UNITED STATES PATENT AND TRADEMARK OFFICE

APPLICATION NO.	FILING DATE	FIRST NAMED INVENTOR	ATTORNEY DOCKET NO.	CONFIRMATION NO.
10/626,592	07/25/2003	Takeshi Matsunaga	240900US2S	9746
22850	7590	01/05/2005	EXAMINER	
OBLON, SPIVAK, MCCLELLAND, MAIER & NEUSTADT, P.C. 1940 DUKE STREET ALEXANDRIA, VA 22314			ORTIZ, EDGARDO	
			ART UNIT	PAPER NUMBER
			2815

Office Action Summary

DETAILED ACTION

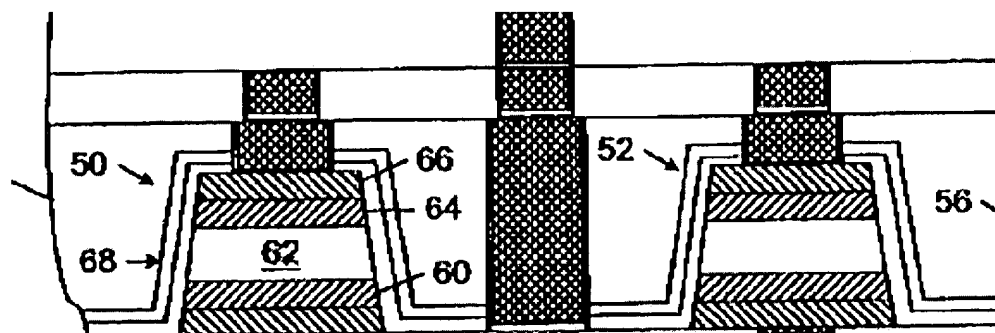
Claims 1-13 are rejected under 35 U.S.C. 102(e) as being anticipated by Moise et al. (U.S. Patent No. 6,734,477). With regard to Claim 1, Moise discloses a semiconductor device having a capacitor formed in a multilayer wiring structure, the semiconductor device comprising:

a multilayer wiring structure (figure 1) including a plurality of wirings layers (12, 14, 16, 18, 22) formed on a substrate (26);

a capacitor (50 or 52) arranged in a predetermined wiring layer (16) in the multilayer wiring structure and having a lower electrode (60), a dielectric film (62), and an upper electrode (64);

a first via formed in the predetermined wiring layer (16) and connected (figure 1); to a top surface of the upper electrode (64) of the capacitor (50 or 52); and

a second via formed in an overlying wiring layer (18) stacked on the predetermined wiring layer (16), the second via being formed on the first via (figure 2).

With regard to Claim 2, Moise discloses a first via that is formed to have a larger cross section than that of the second via (figure 1).

With regard to Claim 3, Moise discloses a predetermined wiring layer (16) having a third via formed on the lower electrode (60) and a wiring connected to the third via (column 4, lines 3-7) and buried in a surface of the predetermined wiring layer (figure 1).

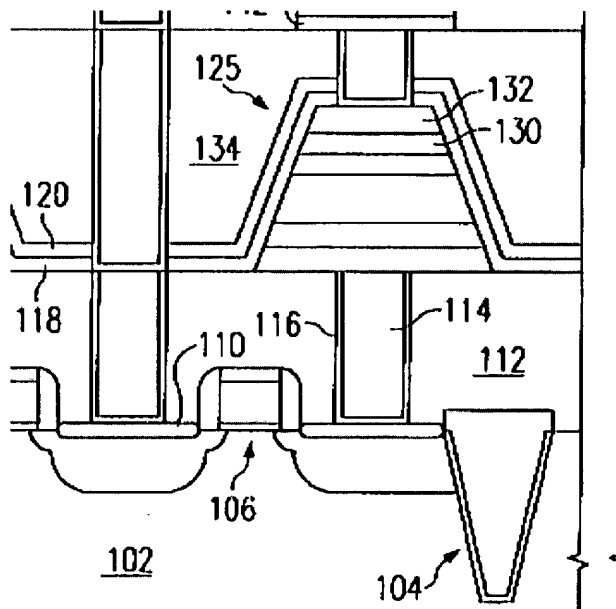
Claims 5-6 are rejected under 35 U.S.C. 103(a) as being unpatentable over Moise et al. (U.S. Patent No. 6,734,477) in view of Moise et al. (U.S. Patent No. 6,534,809). With regard to Claims 5-6, Moise ('477) discloses a predetermined wiring layer (16) having a third via formed on the lower electrode (60), a wiring connected to the third via (column 4, lines 3-7) and a metal-diffusion stopper film (column 4, lines 38-42) on a surface of the predetermined wiring layer.

Moise ('477) fails to disclose the claimed wiring comprising copper. However, Moise ('809) discloses (figure 1) a semiconductor device including a capacitor structure (125) having a bottom electrode (124) and a via having a wiring (114) connected to the via, wherein the wiring comprises copper (column 7, lines 42-46).

Therefore, it would have been obvious to someone with ordinary skill in the art, at the time of the invention, to modify the structure as taught by Moise ('477) to include the claimed wiring comprising copper, as suggested by Moise ('809), in order to form contacts to the substrate and gate structures (column 7, lines 39-42) and filled with a material (copper) known in the semiconductor art for its good conductivity.
